## **Product Bulletin**

Document # : PB21550X Issue Date: 2 December 2016

Title of Change:	Conversion from polarity notch to polarity band on SMC packaged products.		
Effective date:	9 March 2017 or earlier upon customer approval		
Contact information:	Contact your local ON Semiconductor Sales Office or < <u>SitiNurhaza.MohdRamli@onsemi.com&gt;</u> or < <u>SengMun.Yoon@onsemi.com&gt;</u>		
Type of notification:	This Product Bulletin (PB) is sent to customers. PB is issued 90 days prior to implementation of the change. ON Semiconductor will consider this change accepted, unless an inquiry is made in writing within 30 days of delivery of this notice. To do so, contact <pcn.support@onsemi.com>.</pcn.support@onsemi.com>		
Change category:	☐ Wafer Fab Change ☐ Assembly Change ☐ Test Cha	nge  Other	
Change Sub-Category(s):  Manufacturing Site Change/ Manufacturing Process Char		☐ Datasheet/Product Doc change ☐ Shipping/Packaging/Marking ☐ Other:	
Sites Affected:  ☐ All site(s) ☐ not ap	cable ON Semiconductor site(s): ON Seremban, Malaysia	☐ External Foundry/Subcon site(s)

Figure 1 Figure 2

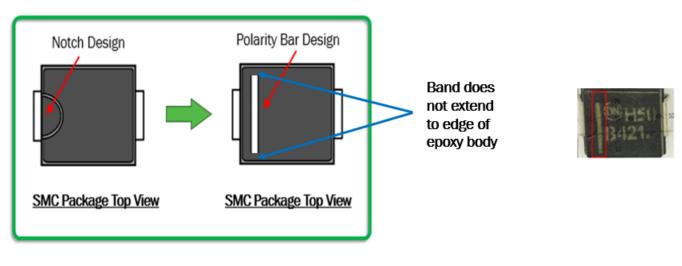
This Product Bulletin is announcing that ON Semiconductor Malaysia is converting the diode polarity identification for SMC packaged devices from a notch molded into the epoxy body of the device to a laser marked polarity band. The change will align ON Semiconductor Malaysia with the current industry standard for SMC polarity identification. The details of this change are displayed pictorially in Figure 1 below. An example device showing both the legacy notch that will be eliminated and the polarity band that will be replacing it is shown in Figure 2.

During the transition period, both notches and the laser marked polarity band can be present within a same reel and packaging. As this change affects only external appearance, there is no product reliability and characterization testing required.
